SR-2 – ADVISORY STAFF REPORT (03-06-2026)

ADDRESS: 1069 MANISTIQUE

APPLICATION NUMBER: HDC2026-00051

SCOPE: ERECT TRASH ENCLOSURE, REHABILITATE BUILDING

Proposed trash enclosure, drawings applicant's submission.

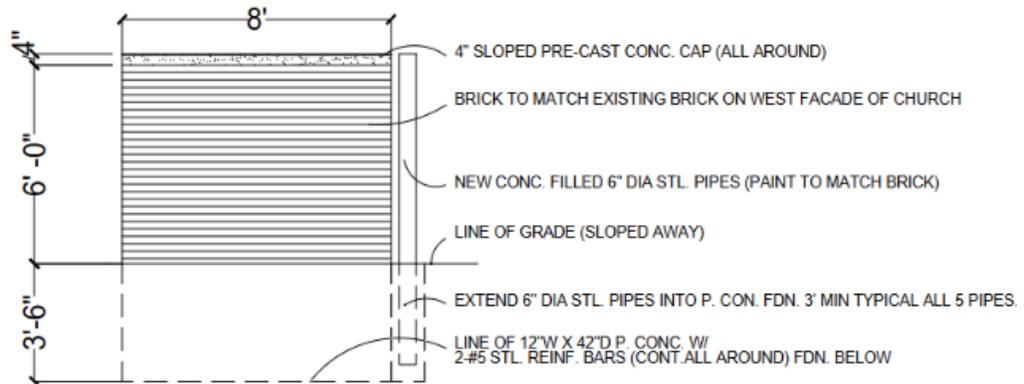
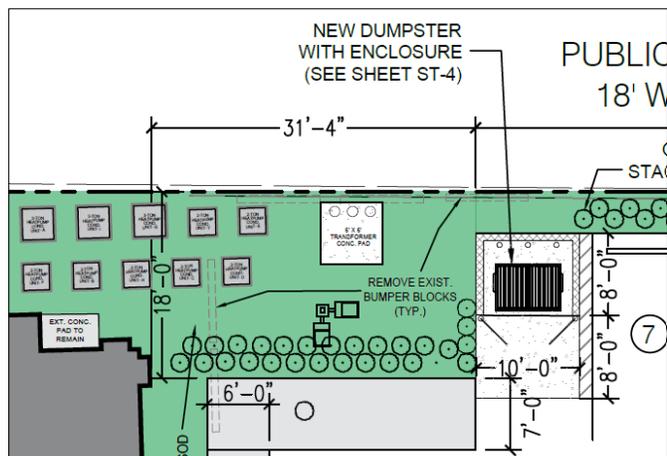
1. The limestone wall will not be a compatible wall type for the proposed trash enclosure; a more utilitarian style beige brick would be more appropriate.

- However, the rendering provided by the applicant (shown below), shows the trash enclosure uses contemporary stone cladding to mimic the limestone wall, which differs from the architectural drawings provided that show the proposed brick to match the rear, west elevation
- It is staff opinion that the beige brick, as depicted in the drawings, would be a more compatible material for the trash enclosure, and a less disruptive addition to the historic property. It would also be compatible with the “back of house” brick expression used at the rear of the church building.

1. The utilitarian beige brick be a used for the proposed trash enclosure.

Rear elevation provided by applicant.

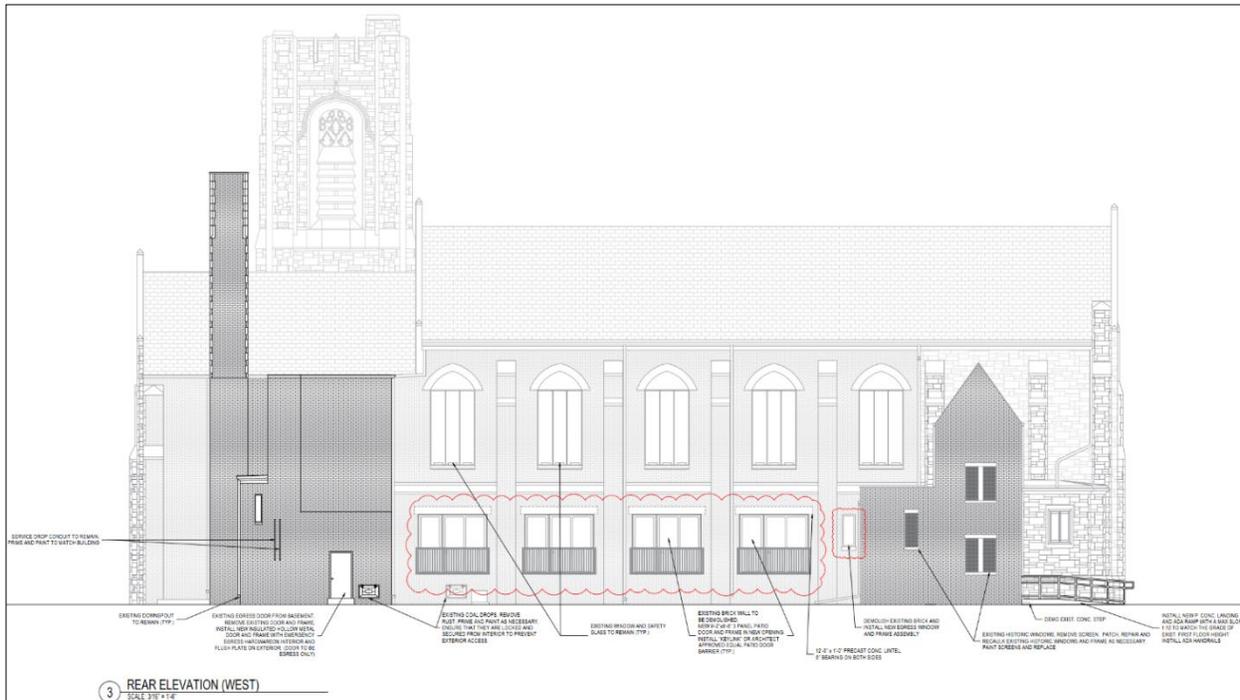
Highlighted: proposed four (4) sliding door additions and one (1) egress window

- It is Staff’s assessment that the addition of the sliding doors and railings will not impact the historical integrity of the building, for the following reasons:

- The placement of the sliding doors and railing, generally appear to be a compatible alteration to the rear, per the National Parks Service guidelines in the Illustrated Guidelines on Sustainability for Rehabilitating Historic Buildings, in their section on Daylighting:

- **Not Recommended:** *Adding new window openings on primary elevations that will negatively impact the character of the historic building.*
 - The rear location is a less visible façade and the addition of natural light will not impact any historic, character defining area of the historic church.
